Annex 113A

Description of cable clamp and test setup

Figure 113A-3 - Cable clamp validation test configuration

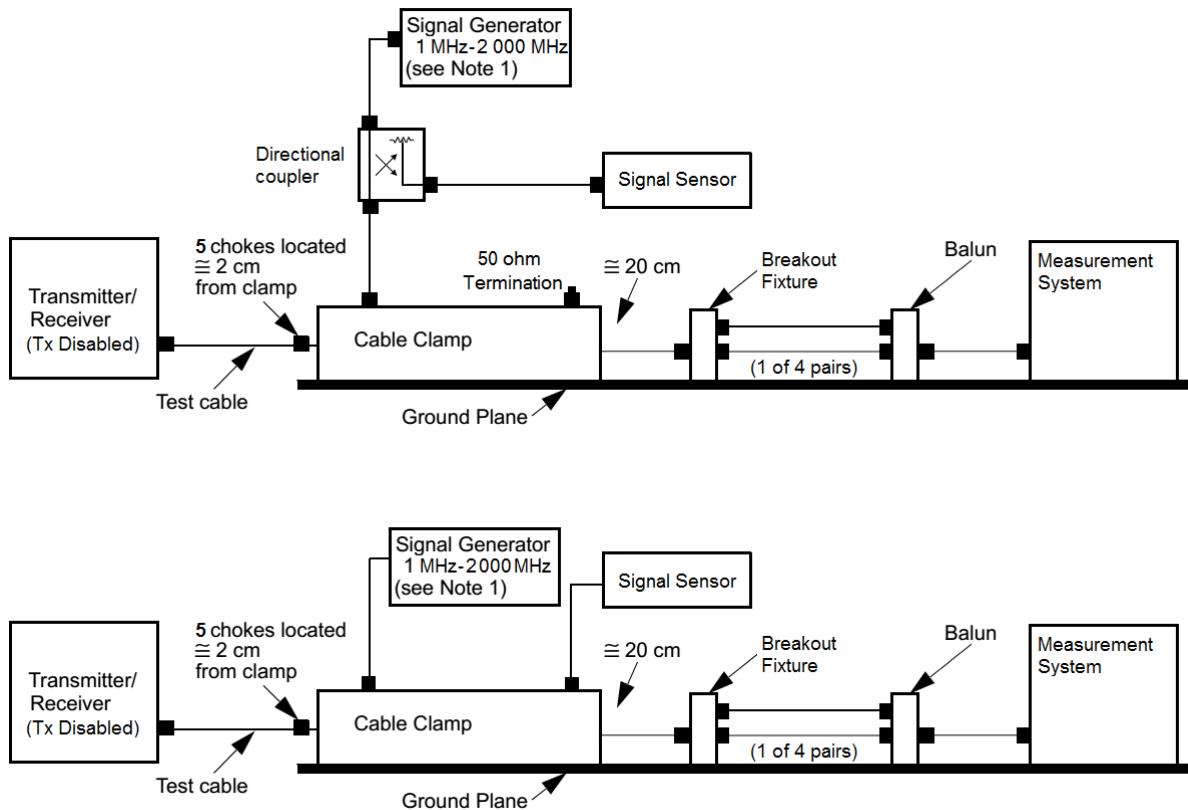
The use of two separate differential and common-mode signal component measurement configurations is permissible provided the above specifications are met for each measurement device.

The common-mode reference (termination) impedance may be standard specific. The common-mode return loss requirement does not change, but Z_{ref} (common-mode) may be 50 Ω for shielded or 75 Ω for UTP-unshielded applications.

~~The use of two separate differential and common-mode signal component measurement configurations is permissible provided the above specifications are met for each measurement configuration.~~

~~Note that other devices for detecting differential and common mode signals may also be used.~~
